H17	BT00.00-X-1000Z	Technical modifications	9.12.98
------------	-----------------	--------------------------------	----------------

K17	BT35.31-P-9402-01A	Integrated thrust washer on tapered roller bearing inner race		 BT
------------	--------------------	---	--	---

P35.31-0275-01

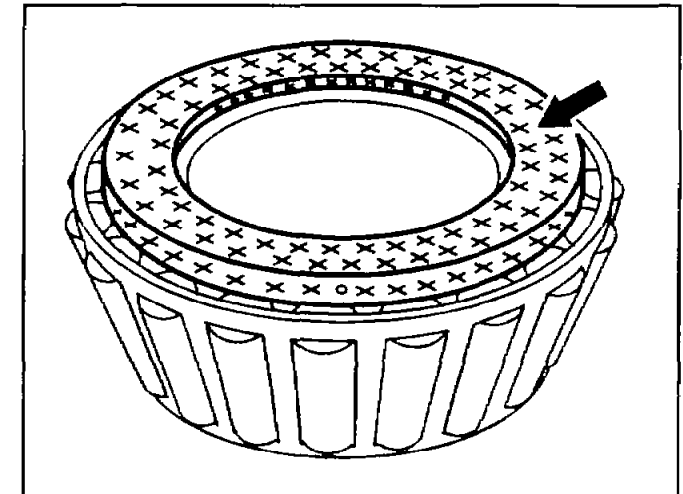
The thrust washer is permanently integrated on the small tapered roller bearing inner race of the drive pinion to facilitate assembly.

The thrust washer was clipped onto the tapered roller bearing inner race with 3 retaining lugs on the previous version.

L17	BT35.31-P-0012-01A	Radial seal ring and joint flange on drive pinion modified		 BT
------------	--------------------	--	--	---

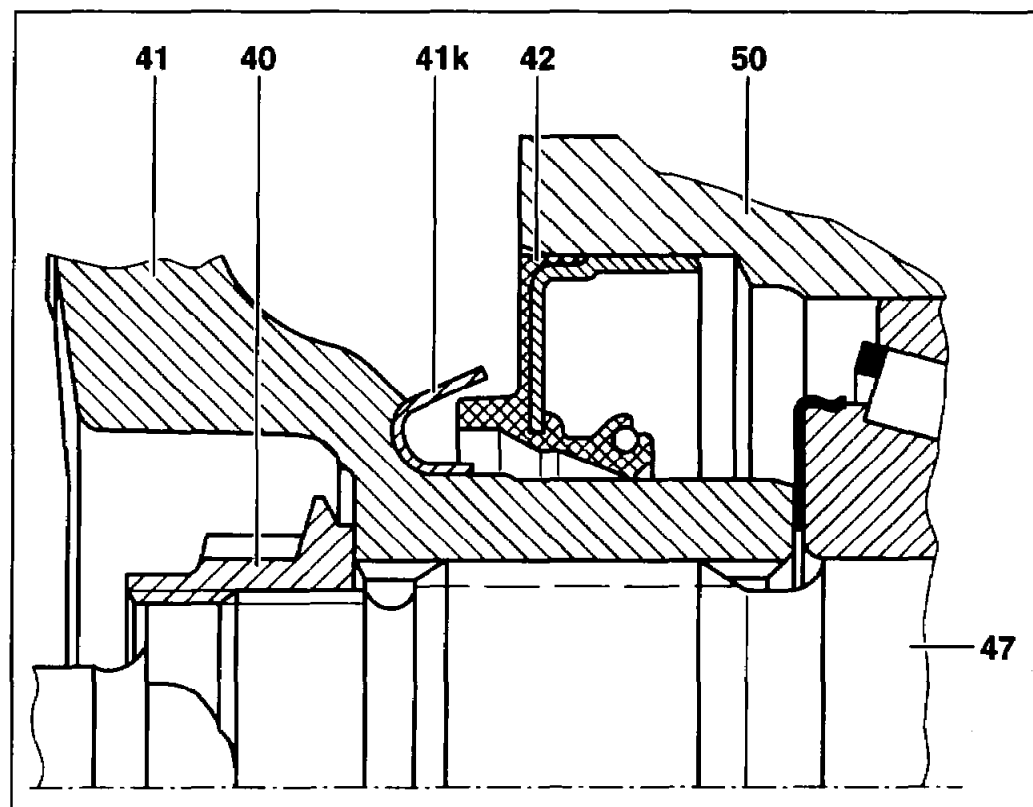
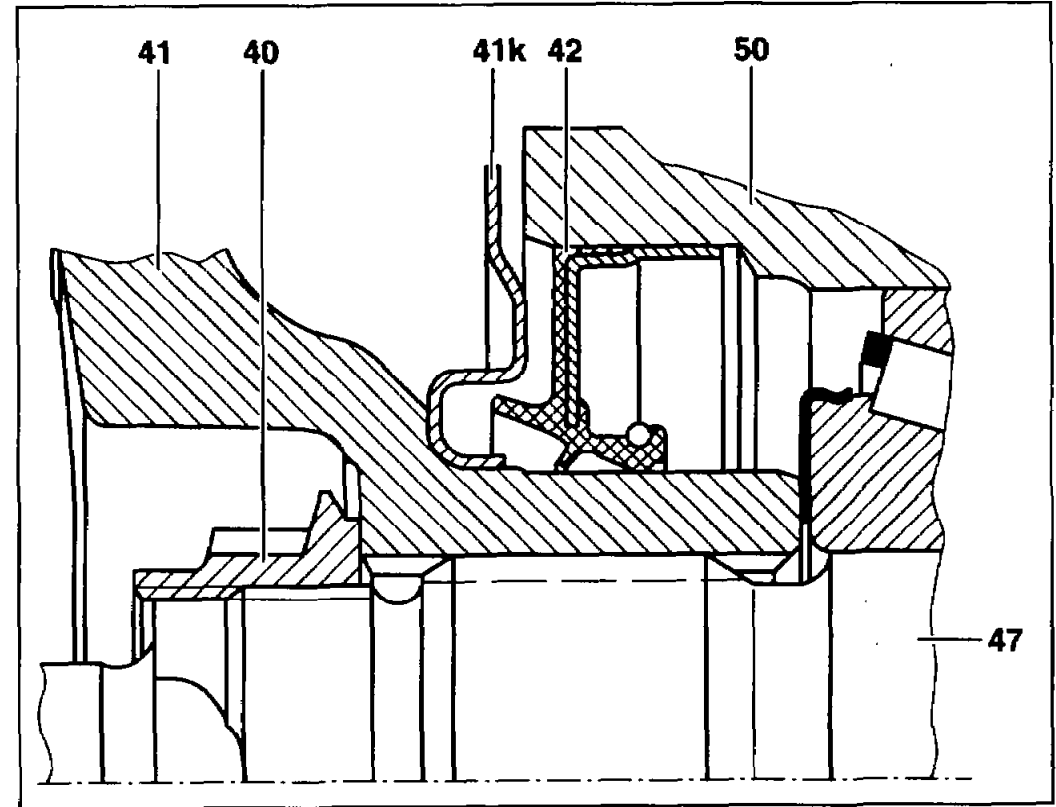
A new radial seal ring and new joint flange with protective ring has been fitted, phased in as of 01.04.98.

This improves the sealing on the drive pinion against dirt from outside.

When installing the **new joint flange**, it is essential to install the **new radial seal ring** as well. This is the only way to ensure correct sealing

When the new radial seal ring is installed, the previous joint flange can continue to be installed.

A18	BT35.31-P-0009-01A	Connecting flange with centering		BT
------------	--------------------	----------------------------------	--	-----------

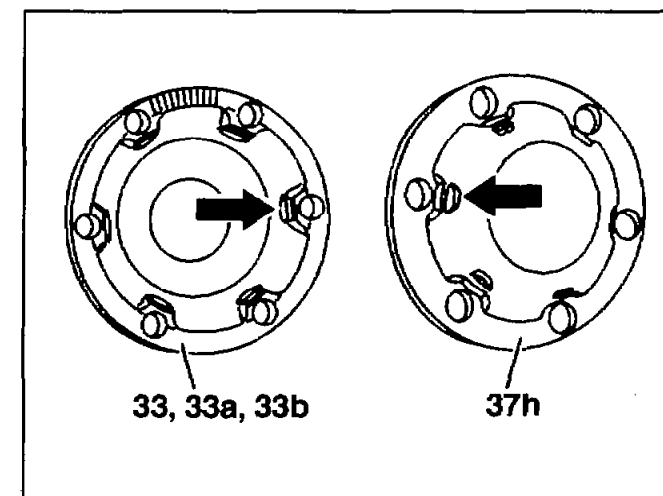
Connecting flange with centering.

The connection between the flange (33, 33a, 33b) and rear axle shaft has been made more accurate and the concentricity has been improved. The connecting flange (33, 33a, 33b) has turned surfaces and the end cover (37h) of the rear axle shaft has impressions (arrows).
